drawing 110: **PALM TREE COURT**

Plans

Factory Lane, Tottenham, N17 9F

hunters project number:	drawing number:	drawn by	checked by/	scale
M10079-HUN-PTC--1F-DR-A-APL-05-0003	JS	MB	1:100	@A

02 Palm Tree Court - Proposed First Floor Plan
1:100

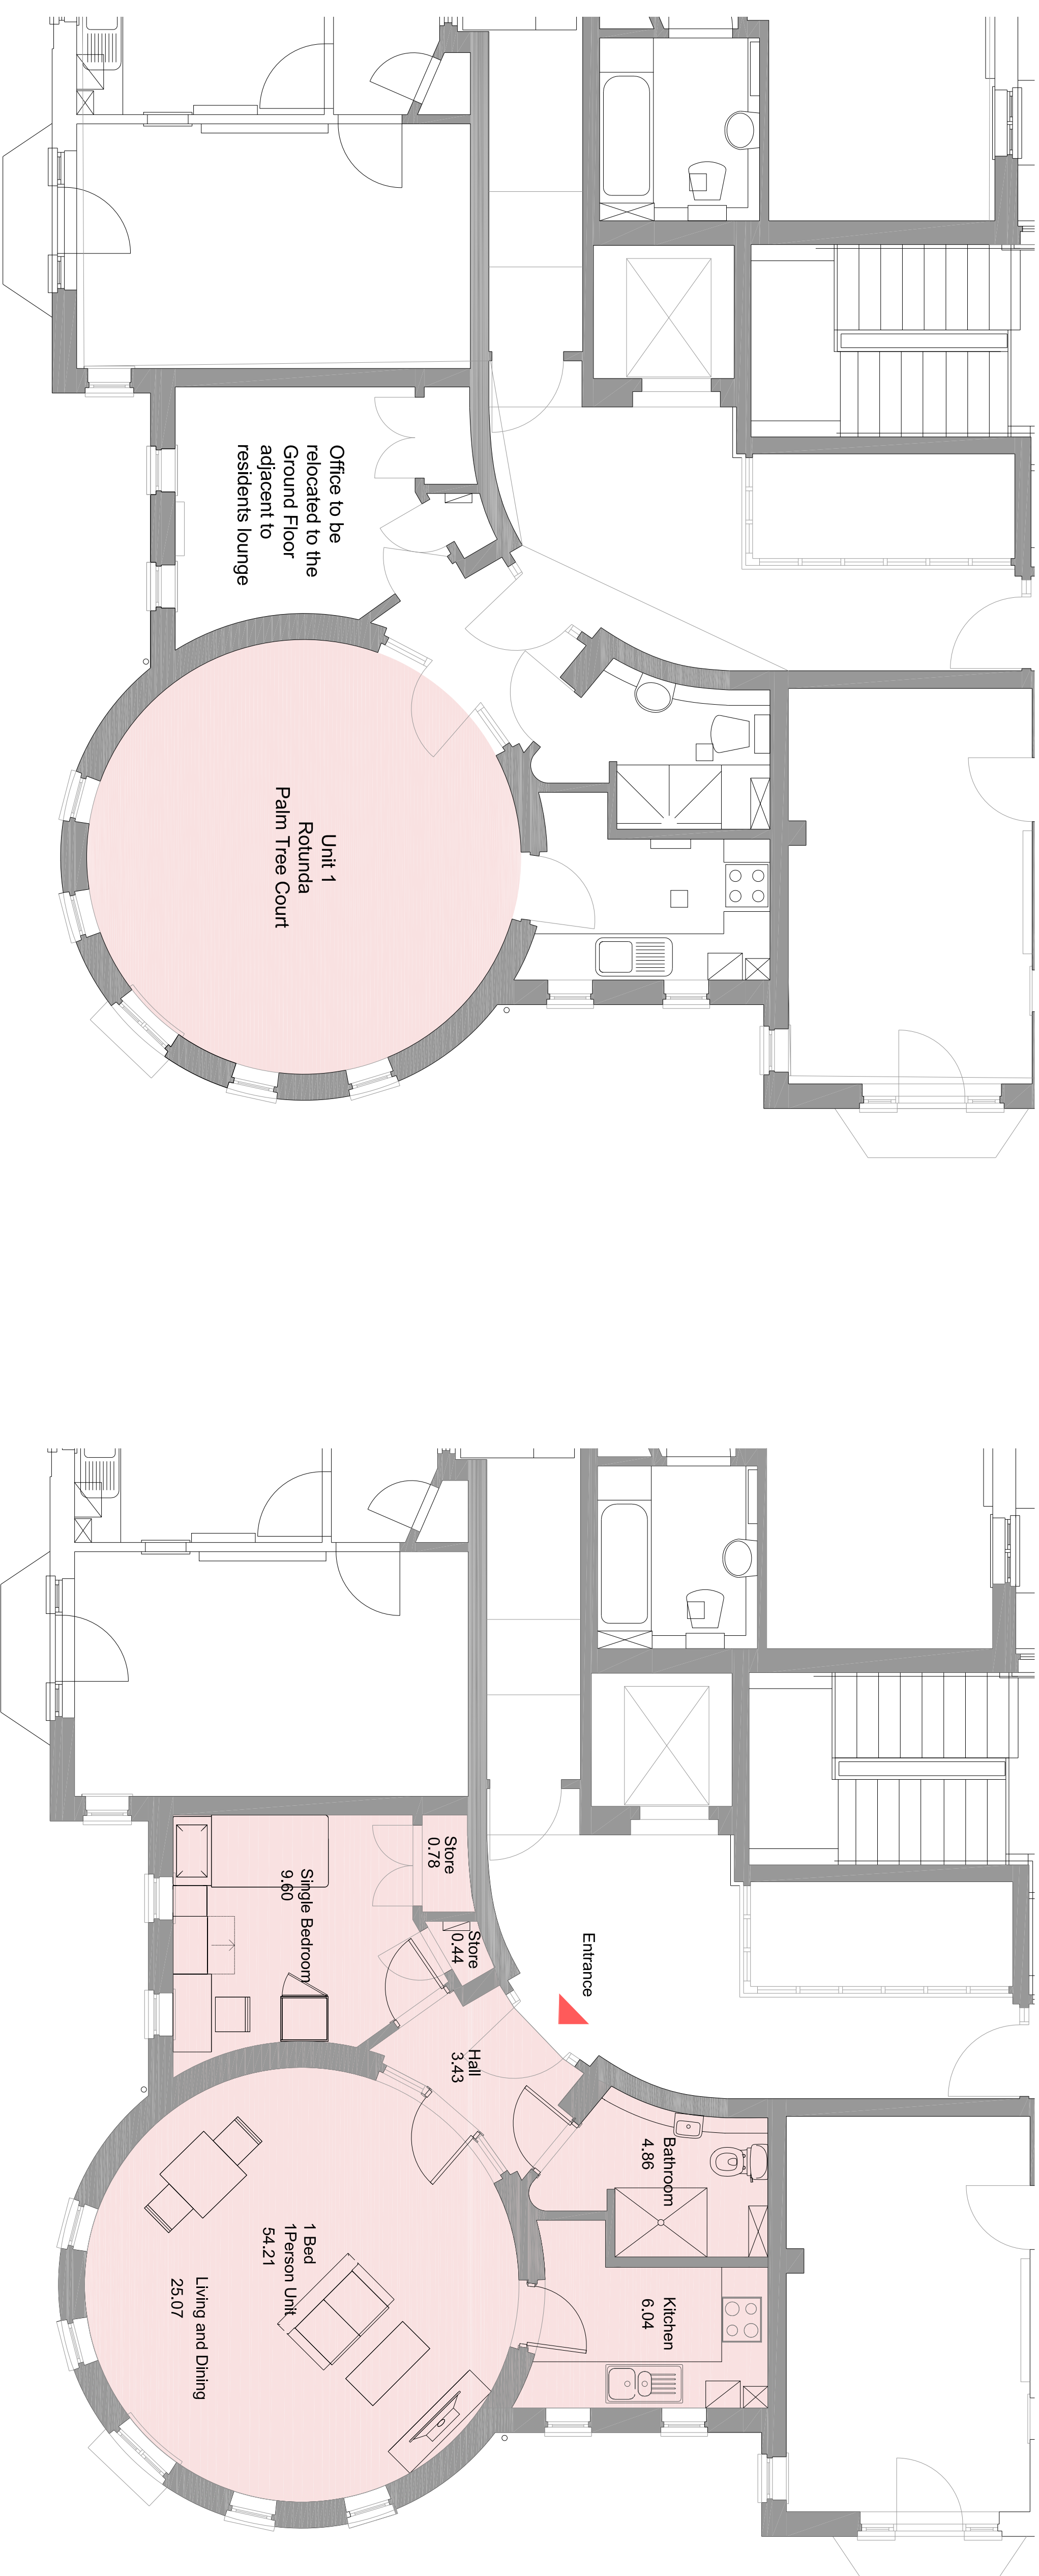
NOTES: 10.03.2023 - Revised to convert Guest Room to One Bedroom, One Person unit to reflect an updated client brief
